Vogtle Electric Generating Plant (VEGP) Units 3 and 4

Request for License Amendment:

**Tornado Missile Protection for Main Steam Vent Stacks and Wall 11
(LAR-19-014)**

**Proposed Changes to Licensing Basis Documents
(LAR-19-014)**

Figure 1-2: AP1000 Plant Building Arrangement

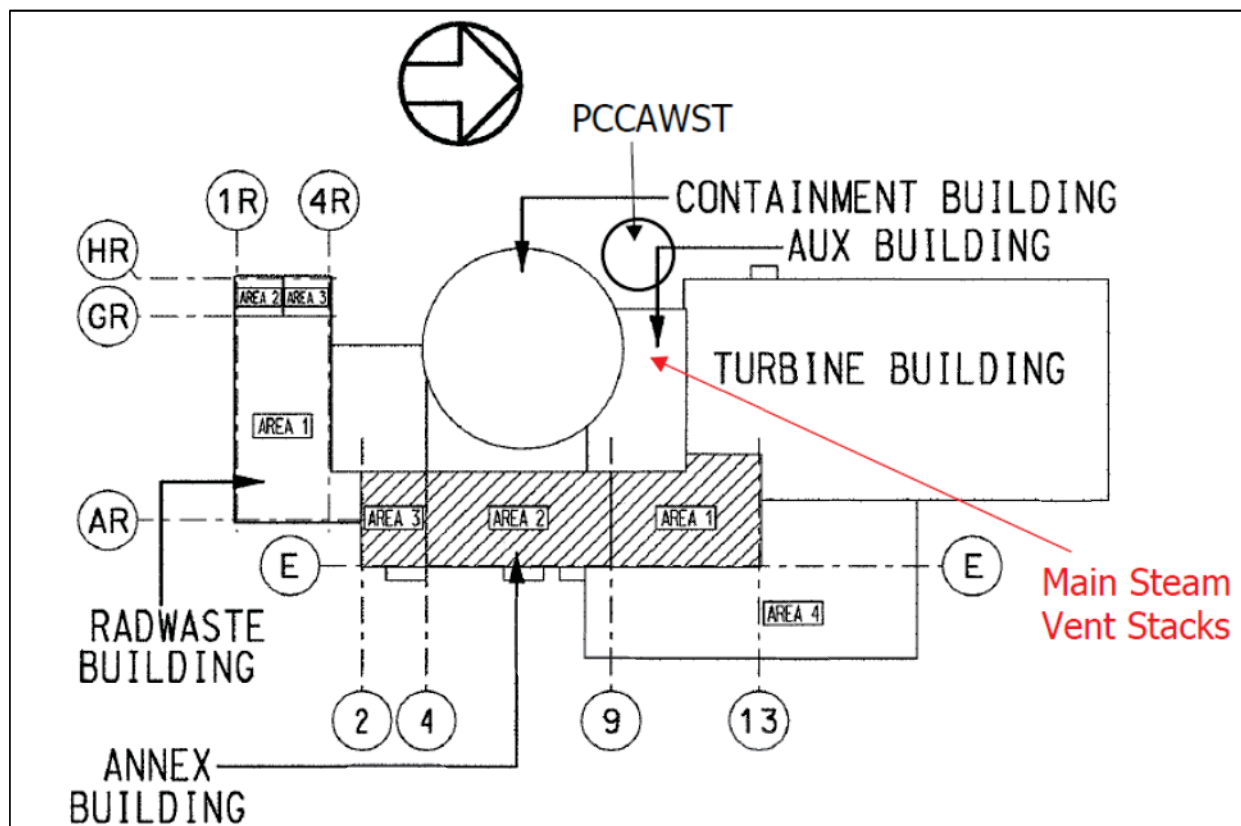
Based on the Vogtle site specific topography and site layout, there is a limited line of sight to the main steam vent stacks. As shown in Figure 1-2, the Annex Building, Containment Building (Shield Building), Turbine Building First Bay, and Passive Containment Cooling Ancillary Water Storage Tank (PCCAWST) surround the Auxiliary Building roof where the main steam vent stacks are located. As shown in Table 1-1, the surrounding structures exceed the elevation of the Auxiliary Building roof low point and will provide protection to the main steam vent stacks. The Annex Building (Column 2 to 9), Shield Building, Turbine Building First Bay, and PCCAWST are above the elevation required to be evaluated for automobile missiles and will prevent an automobile from hitting the main steam vent stacks. The Annex Building (Column 9 to 13) elevation is below the max elevation evaluated for automobile missiles by 18". Due to the size of large debris (16.4' x 6.6' x 4.2'), part of the debris would hit the Annex Building (Column 9 to 13) wall and cause a ricochet. Therefore, there is no line of sight for automobile missiles if these buildings are in the missile path.

The Shield Building is Seismic Category I. The Turbine Building First Bay, Annex Building (portion credited), and PCCAWST are Seismic Category II as shown in UFSAR Table 3.2-2 and Table 3.2-3. As described in UFSAR Subsection 3.3.2 and 3.5.2, Seismic Category I and Seismic Category II structures are designed to withstand the design basis tornado loads, including missiles. Therefore, the structures will stop the automobile missile from reaching the main steam vent stacks.

Based on the elevation of the vent stacks, Vogtle site topography, and arrangement of surrounding building, an automobile missile is not a credible impact on the vent stacks.
